SERVICE LETTER NUMBER 144			
TITLE: DRAG STRUT ATTACHMENT, WASHER REPLACEMENT			
BY: MAB	AIRCRAFT MAKE/MODEL(S):	FLOAT MODEL(S):	NOTE(S):
APP: SDW	FIREBOSS AIR TRACTOR 802 & 802A	10000	MANDATORY COMPLIANCE S/L P/N 1005968
DATE: 5/21/2019			
REV: C.1

This service letter applies to all S/N 10126A and prior Wipline model 10000 amphibian floats, as installed on "Fireboss" Air Tractor 802 and 802A aircraft. This service letter applies to Air Tractor 802/802A aircraft equipped with STC SA01795CH.

Figure 1: Attachment Location (Strut Fairings Removed)

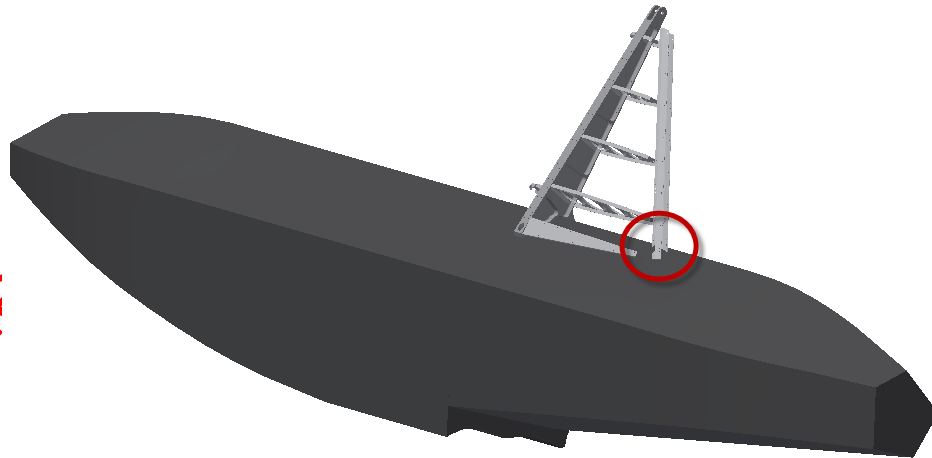
The bolted attachment of the drag strut to the float has been found to cause coning of the flat washers both under the bolt head and the nut. Deformation of the washers in turn results in a loose bolted attachment.

NOTES: Figure 1 shows the attachment location in question and Figure 2 details the hardware replacement that must be made.

Figure 2: Hardware Replacement Detail

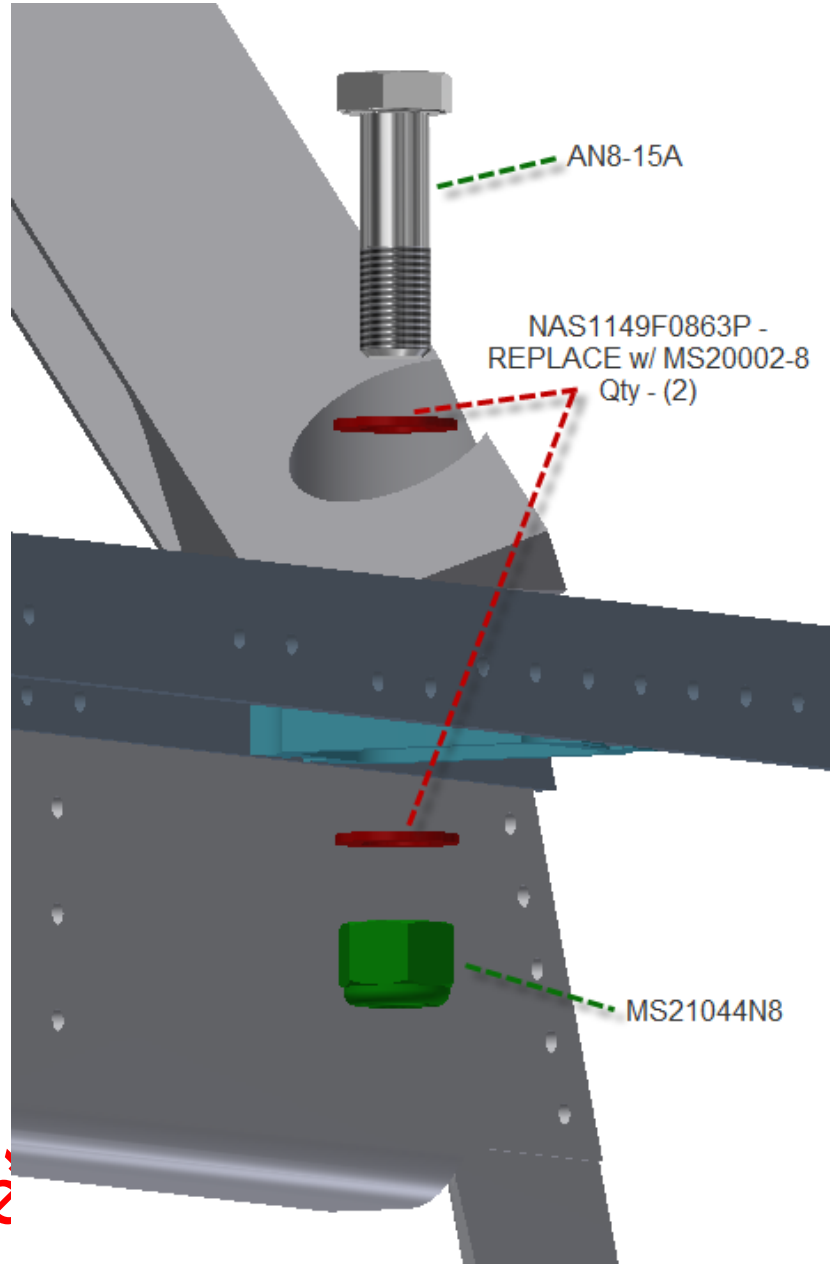
Removal and replacement of the two (2) standard NAS1149F0863P flat washers in the float to drag strut attachment with high strength MS20002-8 plain washers.

3. Replace existing NAS1149 washers with MS20002 washers and reinstall bolt. Re-torque to 480-690 in-lbs (40-57.5 ft-lbs).
